TAKACHI ELECTRONICS ENCLOSURE CO., LTD.

NOTICE

IP65 PLASTIC BOX SMALL TYPE BCAS Series Mold Renewal and Design Change

◆BCAS101007G、BCAS101010G models

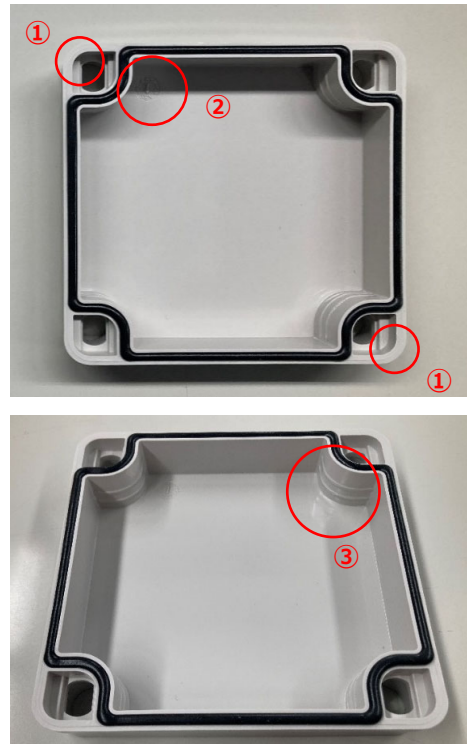
- Revised shape of the fitting part of the corners on top cover. *Refer to ①
- Revised markings and position, eliminated production lot marking. *Refer to ②
- Slight groove protrusion added to the 4 inner corners of the top cover. *Refer to ③

◆BCAS151507G、BCAS151510G models

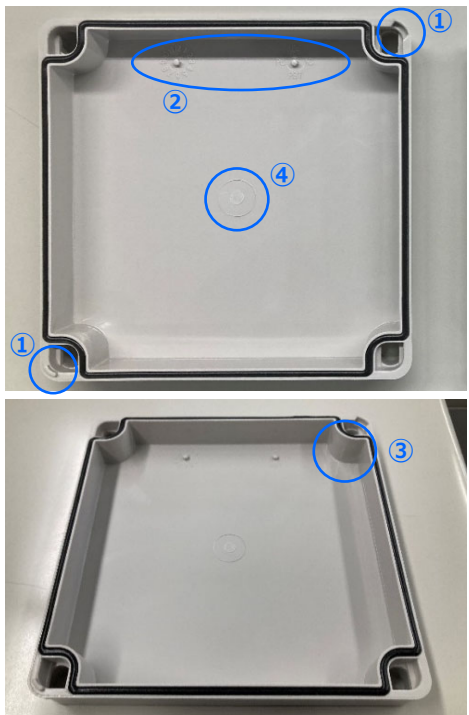
- Revised shape of the fitting part of the corners on top cover. *Refer to ①
- Revised markings and position, eliminated production lot marking. *Refer to ②
- Slight groove protrusion added to the 4 inner corners of the top cover. *Refer to ③
- Eliminated gate mark on the center on top cover. *Refer to ④
